Re: Request for Access to Records under the Freedom of Information and Protection of Privacy Act (the "Act")

All past alternative solutions and code consultant letters related to 2001 Nanton Avenue (4226 Arbutus Street is the old address for the same property).

Be: Application for Permit - 4225 Arbutus St.

AL-1 Attachment 1

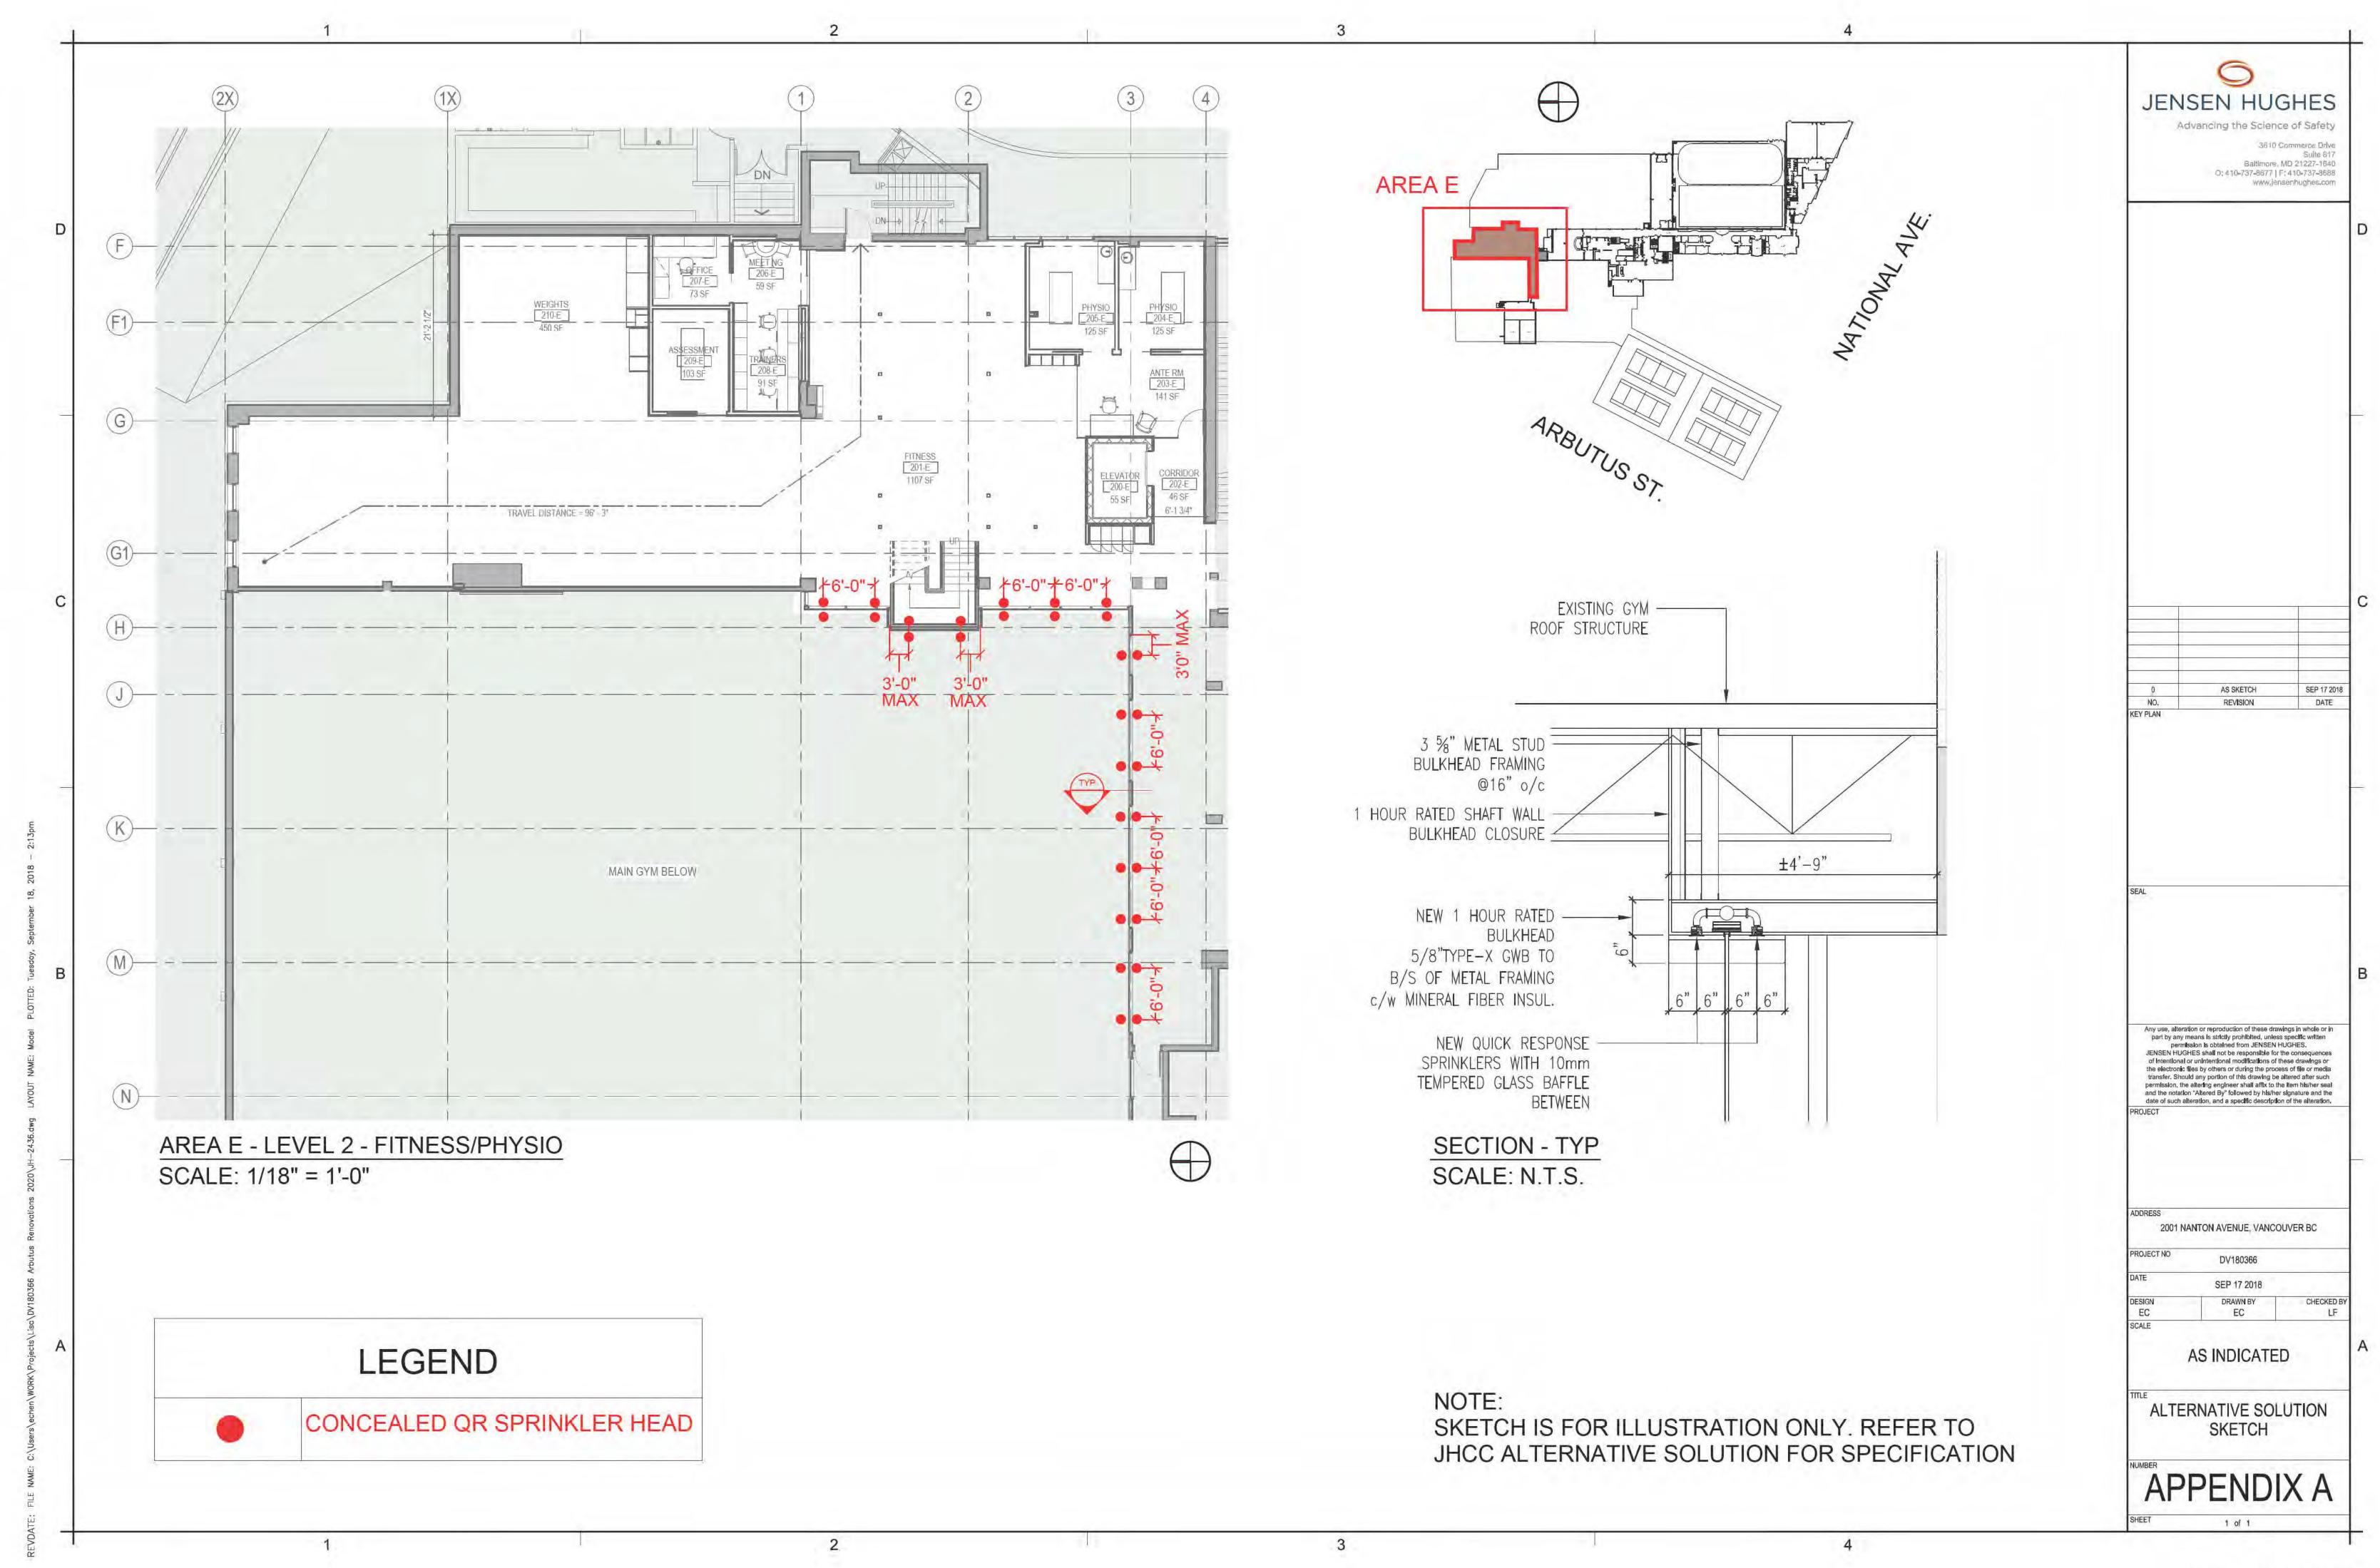
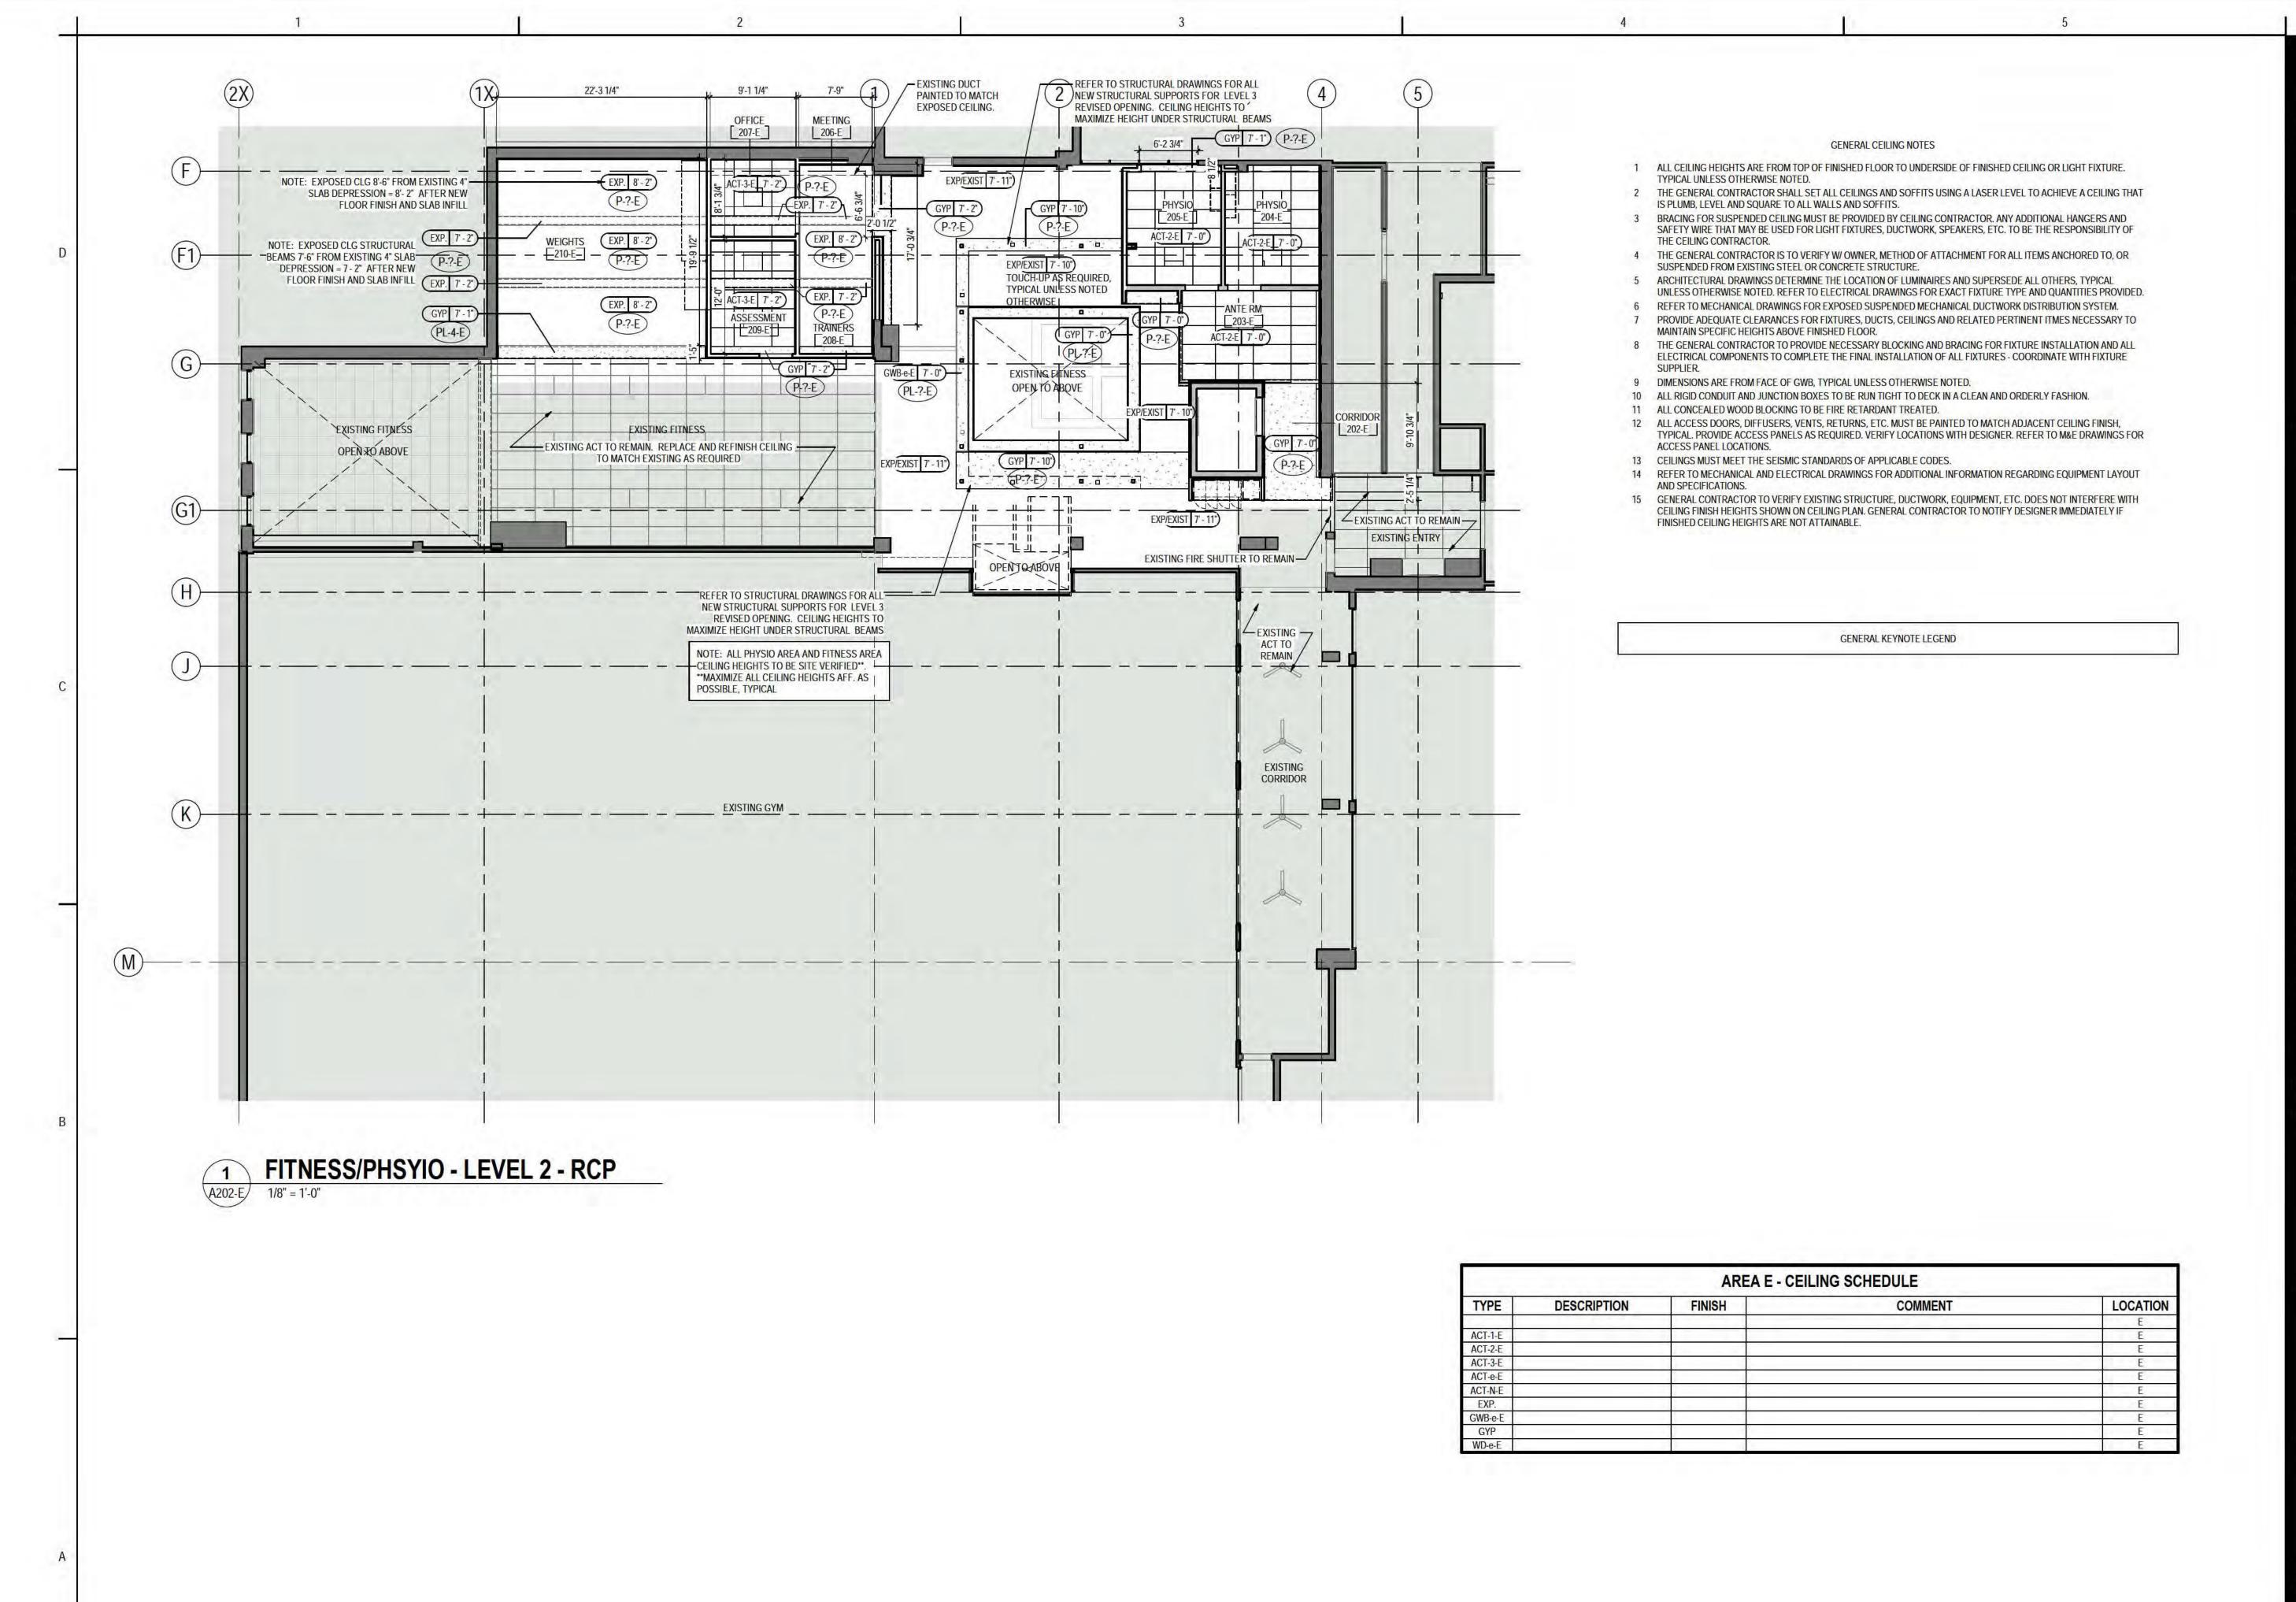
To provide protection around the floor opening, closely spaced sprinklers will be provided at the 2<sup>nd</sup> Floor ceiling around the opening. (See Attachment 1).

The proposed closely spaced sprinkler protection system will provide an equivalent level of protection for the floor separation as required of the VBBL.

# Appendix A Sketches

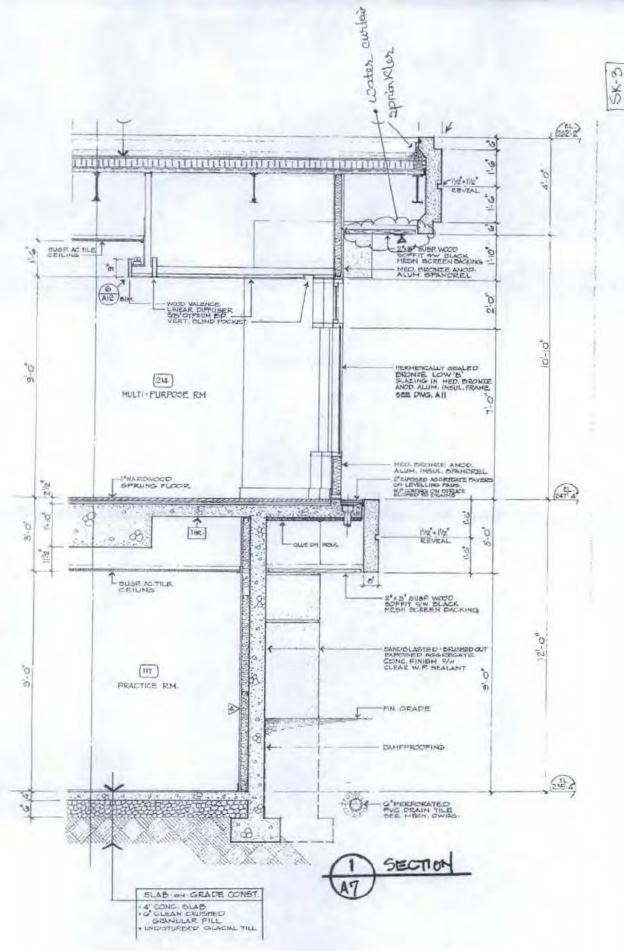
The proposed air supported structure will be erected approximately 3.0 m to the new building and approximately 1.2 m to the existing building at the northwest corner. An alternative solution is proposed (please refer to **Section 4.0** of this report) in order to ensure that the proposed location, along with mitigating features, will provide at least the same level of life safety and property protection required by Clause 3.1.6.3.(2)(a) of the VBBL.

It is also proposed to provide a water curtain sprinkler system in order to protect the air-supported structure from the fire originating in the adjacent structures, and similarly to protect the adjacent structures from a fire originating within the air-supported structures. Please refer to **Appendix A** of this report for the proposed location of the water curtain sprinkler system. The water curtain sprinklers will have the following features:

Fencing will provide a full surround to the air-supported structure on the deck of the second floor. The height of the fencing will typically be 11 ft (3.35 m) above the tennis court surface. Should a collapse occur, the fencing will block the structure from draping down the outside of the building, which will ensure that egress routes remain unblocked at the time of emergency.
